Serial: RNP-RA/09-0004

H. B. ROBINSON STEAM ELECTRIC PLANT, UNIT NO. 2
DOCKET NO. 50-261/LICENSE NO. DPR-23

RESPONSE TO REQUEST FOR ADDITIONAL INFORMATION RELATED TO REQUEST FOR RELIEF FROM ASME BOILER AND PRESSURE VESSEL CODE, SECTION XI, SUBSECTIONS IWE AND IWL REQUIREMENTS FOR CONTAINMENT INSPECTIONS

RESPONSE TO REQUESTS FOR ADDITIONAL INFORMATION

FIGURE 1

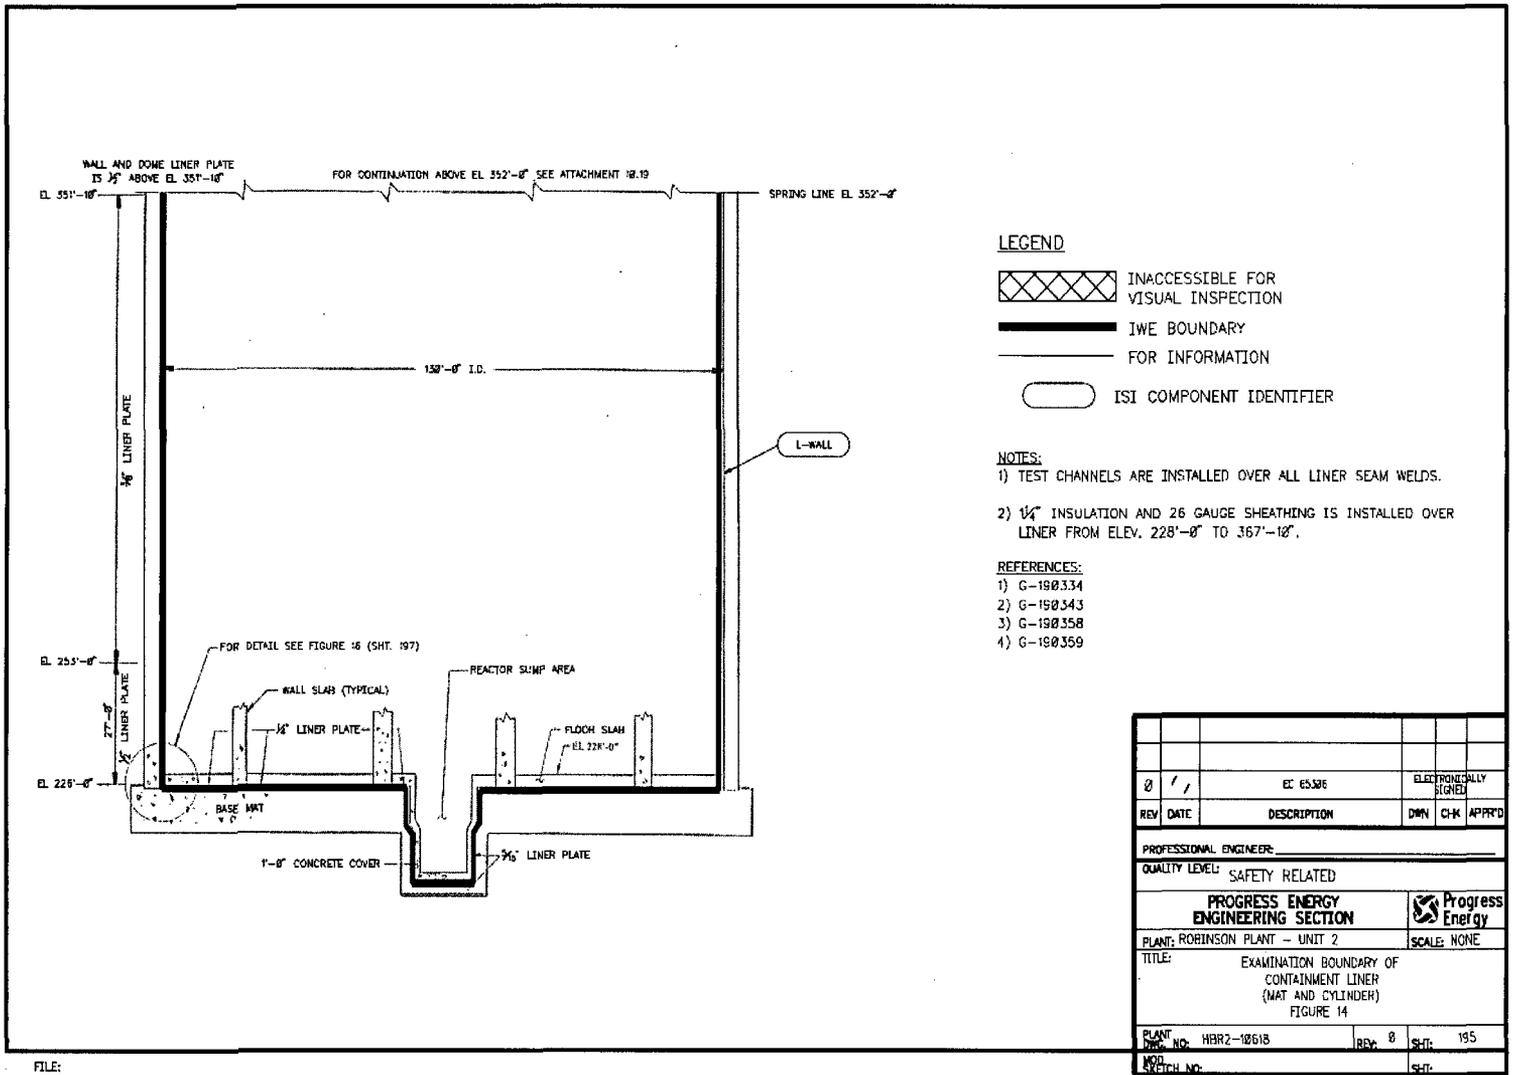
The proposed alternative, as written, could preclude any examination of portions of the containment liner during the inspection interval if there is no maintenance activity that requires removal of the liner insulation in that area. The licensee did not provide a list or schedule of planned maintenance activities to be performed during the inspection interval that would require removal of the insulation panels, thus enabling liner examination. Furthermore, the licensee does not identify target areas where these insulation panels would be removed and the liner examined. Also, there is no commitment on the part of the licensee to perform the general visual examination of at least the critical areas of the insulated containment liner by sampling a reasonable percentage of the inspection areas during the second 10-year containment ISI interval, as was done when similar relief was authorized for the first containment ISI interval.

Therefore, the staff has determined that the proposed alternative, as written, does not provide an acceptable level of quality and safety as required by 10 CFR 50.55a(a)(3)(i). The staff finds that in order for the proposed alternative to meet the requirements of 10 CFR 50.55a(a)(3)(i), the alternative should, as a minimum, commit to perform a general visual examination of critical areas of the insulated containment liner (e.g. the containment wall liner lower areas near the basemat, around openings and penetrations, structural discontinuities, etc.) at least once during the inspection interval by removing a reasonable sample of the insulation panels covering critical areas in order to facilitate liner inspection. Portions of the insulated containment liner that are exposed when a maintenance activity requires removal of the liner insulation may be included in the sample. Based on the above discussion, the licensee is requested to revise its proposed alternative examination to include

a commitment to perform a general visual examination of the containment liner and to identify the areas within the containment liner that would be included in future examination.

IWE/IWL RR-01 has been revised in its entirety and is provided in Attachment II. The revised version includes the proposed requirement to remove approximately one-third of the base mat level of insulation each period, ensuring 100% examination of the liner surface at the level considered to be the most susceptible to degradation over the entire interval. The revision also maintains the requirement to perform liner inspections when any panels are removed for maintenance purposes.

This request for relief is applicable to the insulated portion of the containment liner classified as Class MC and subject to the requirements of Table IWE-2500-1, Examination Category E-A, at the H. B. Robinson Steam Electric Plant (HBRSEP), Unit No. 2 (Figure 1).

Currently, the IWE/IWL Program/Plan identifies 62 insulation panels at the interface between the concrete and the containment base mat (228-foot Elevation). Approximately one-third of the panels at the base mat interface will be removed and a general visual examination of the containment liner performed each examination period during the Second Ten-Year Interval. This will ensure that over the Second Ten-Year Interval, a 100% general visual examination of the liner at the base mat elevation will be performed.

In addition, during the Second Ten-Year Interval, when an insulation panel at any elevation is removed for maintenance activities, a general visual examination of the liner beneath that panel will be performed.

FIGURE 2

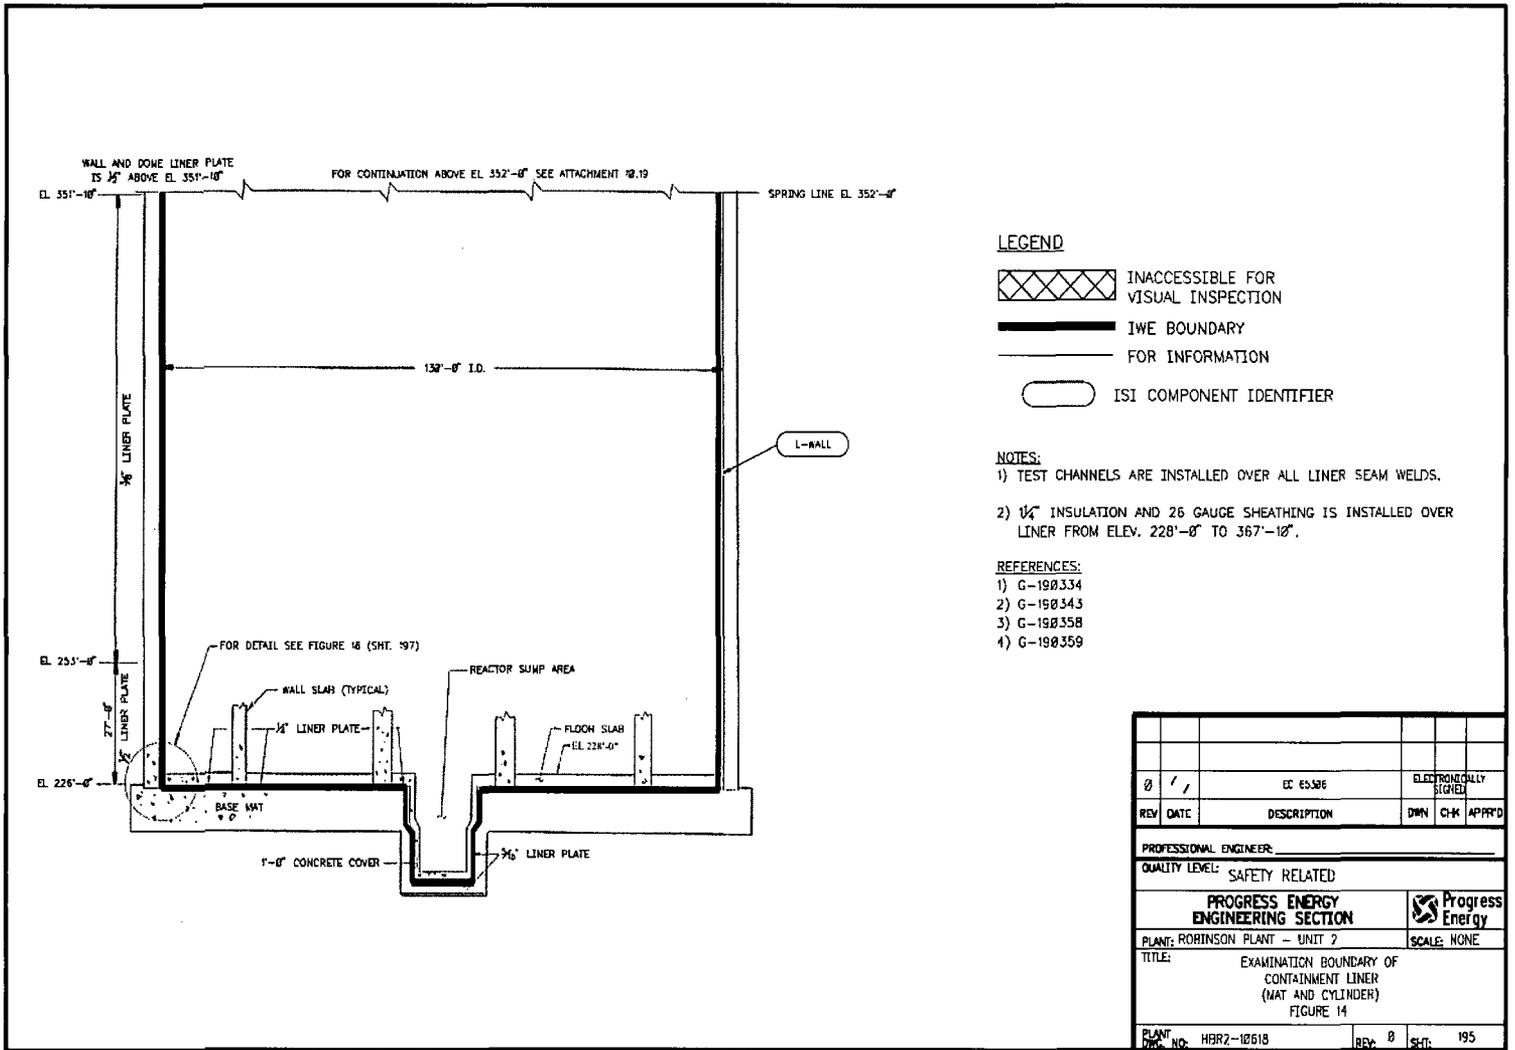
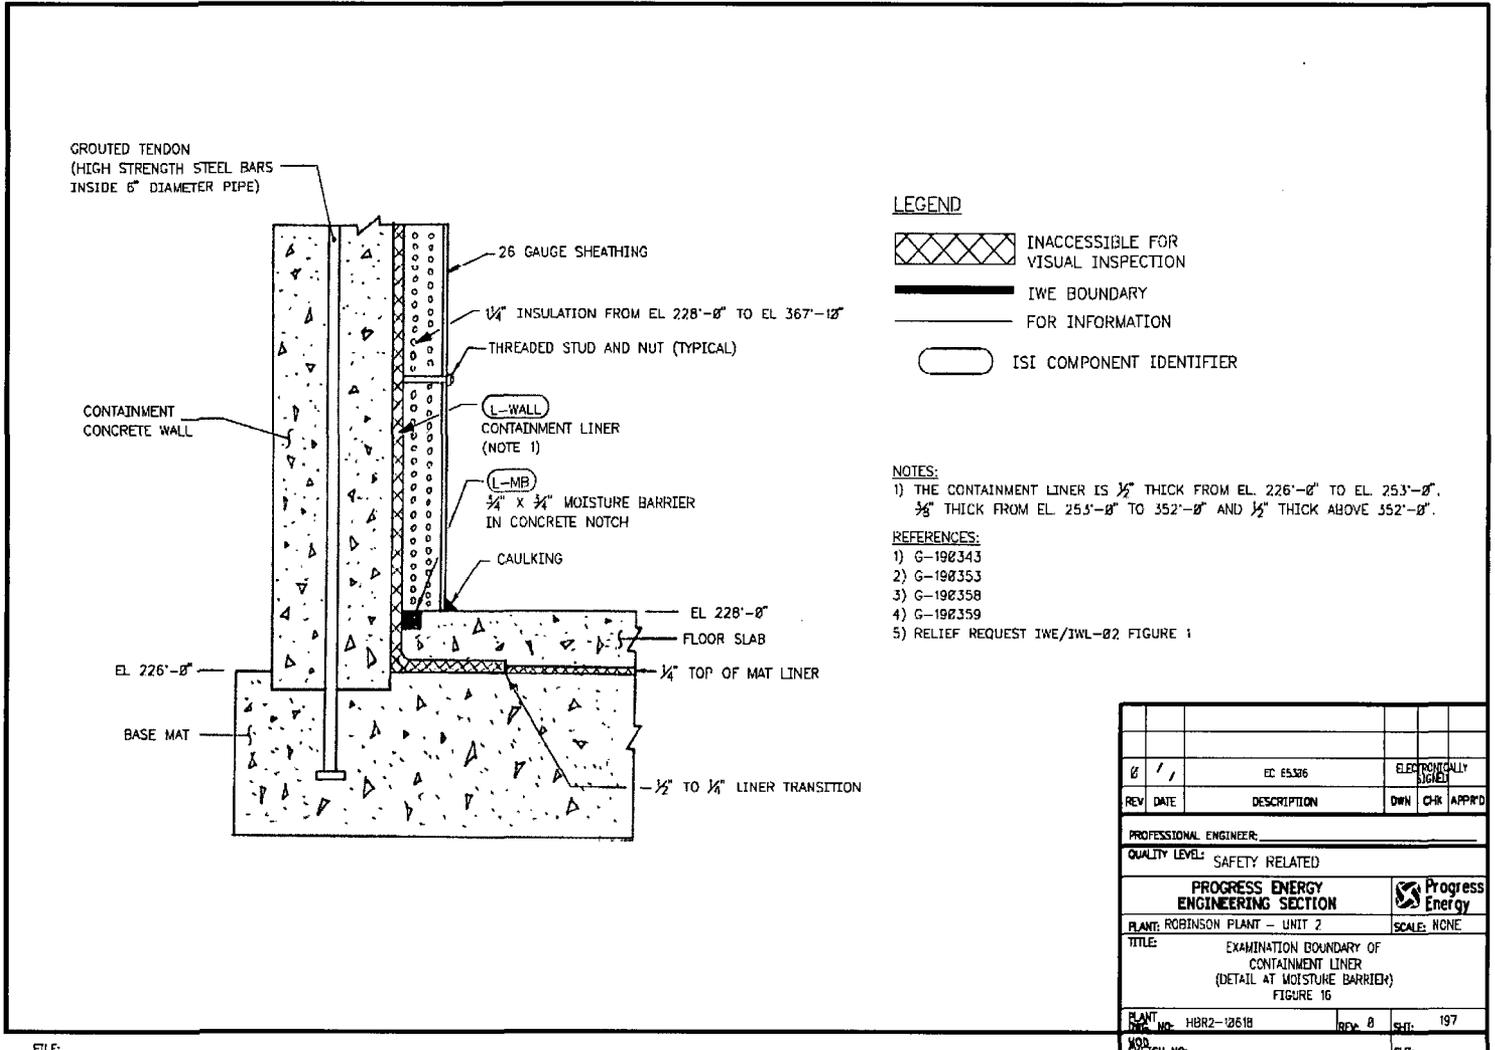
The proposed alternative, as written, could preclude any examination of portions of the moisture barrier during the inspection interval if there is no maintenance activity that requires removal of the lower row liner insulation in that area. The licensee did not provide a list or schedule of planned maintenance activities to be performed during the inspection interval that would require removal (with extent) of the lower row insulation panels, thus allowing moisture barrier examination, as was done when similar relief was authorized for the first containment ISI interval. Furthermore, the licensee takes credit for the insulation covering the liner and moisture barrier as providing an additional moisture barrier, but has not committed to perform any general visual examination of the caulking/water seal (which act as a secondary moisture barrier) near the insulation-concrete slab interface at elevation 228 feet.

Therefore, the staff has determined that the proposed alternative, as written, does not provide an acceptable level of quality and safety as required by 10 CFR 50.55a(a)(3)(i). The staff finds that in order for the proposed alternative to meet the requirements of 10 CFR 50.55a(a)(3)(i), the alternative should, as a minimum, commit to perform a general visual examination of 100 percent of the caulking sealant and water seals at or near the insulation-concrete slab interface at elevation 228 feet (see Figure 2 contained in the licensee's submittal) during each inspection period of the second containment ISI interval. Further, the moisture barrier at the concrete-to-containment liner interface should be subject

to a general visual examination at least once during the second containment ISI interval when the lower row insulation panels are removed for maintenance activities and/or examination of the liner, per the alternative examination for RR IWE/IWL-RR-01 discussed in RAI 2. Considering the above, the licensee is requested to revise its proposed alternative examination to address the stated concern.

IWE/IWL-RR-02 has been revised in its entirety and is provided in Attachment II. The revised version includes the proposed requirement to remove approximately one-third of the base mat level of insulation each period, ensuring 100% examination of the moisture barrier over the entire interval. The revised relief request does not imply any assumed credit for the insulation panels providing a secondary moisture barrier. The justification for the relief is based on the fact that inspections performed to date, after 38 years of operation, have indicated no violation of the required minimum liner thickness, and a commitment to perform a 100% moisture barrier inspection over the Second Ten-Year interval.

This request for relief is applicable to components classified as Class MC and subject to the requirements of Table IWE-2500-1, Examination Category E-A, at the H. B. Robinson Steam Electric Plant (HBRSEP), Unit No. 2 (See Figure 2).

The IWE/IWL Program/Plan identifies 62 insulation panels at the interface between the concrete and the containment base mat (228-foot Elevation). Approximately one-third of the panels at the base mat interface will be removed and a general visual examination of the moisture barrier performed each examination period during the Second Ten-Year Interval. This will ensure that over the Second Ten-Year Interval, a 100% general visual examination of the moisture barrier will be performed.

Additionally, during the Second Ten-Year Interval, when an insulation panel on the 228-foot Elevation is removed for maintenance activities, a general visual examination of the moisture barrier will be performed.

As shown in Figure IWE-2500-1, and noted in Table IWE-2500-1, moisture barrier materials are intended to prevent intrusion of moisture against inaccessible areas of the pressure-retaining metal containment shell or liner at concrete-to-metal interfaces and at metal-to-metal interfaces which are not seal-welded. For HBRSEP, Unit No. 2, the moisture barrier that meets this definition is the epoxy joint filler that interfaces with the concrete-to-containment liner interface at the 228-foot Elevation. Figures 1 and 2 provide details of that interface.
